AMENDMENTS TO THE DRAWINGS

Attached hereto are four (4) sheets of corrected formal drawings that comply with the provisions of 37 C.F.R. § 1.84. The corrected formal drawings incorporate the following drawing changes:

FIG. 5

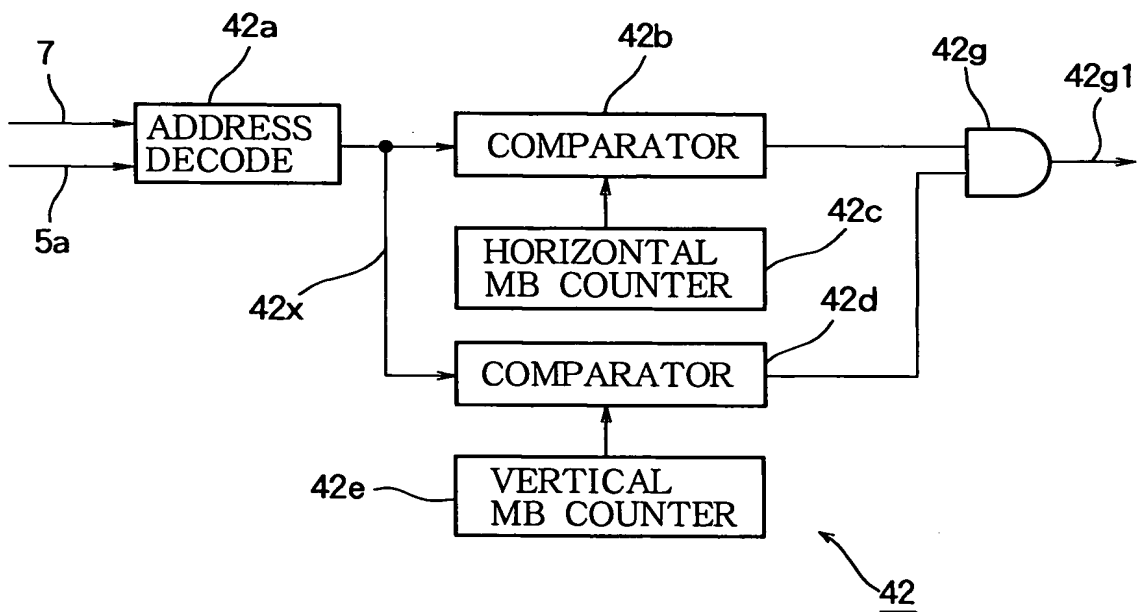
In addition, Fig. 5 has been corrected such that the logical circuit 42g is an AND circuit rather than an OR circuit such that this drawing is consistent with the second embodiment as discussed in the specification.

FIG. 9

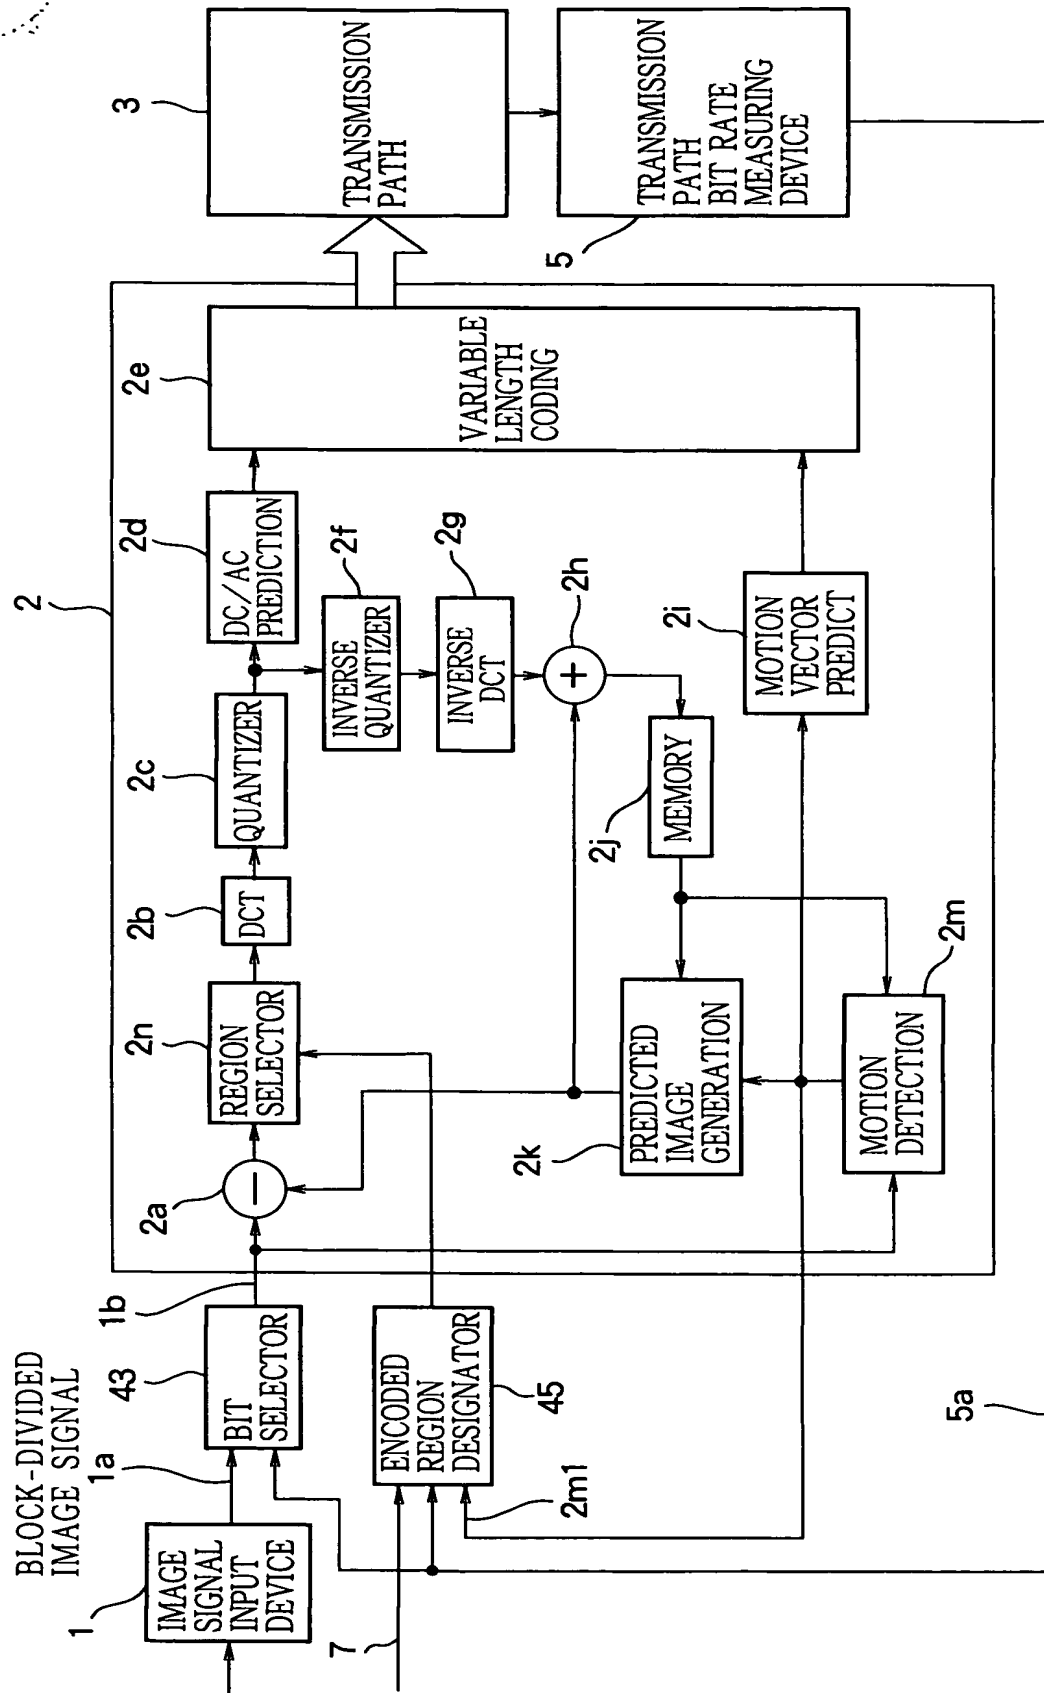
Fig. 9 has been corrected as outlined by the helpful suggestion by the Examiner. Even more specifically, the Encoded Region Designator 45 is now connected to the Region Selector block 2n instead of DCT 2b.
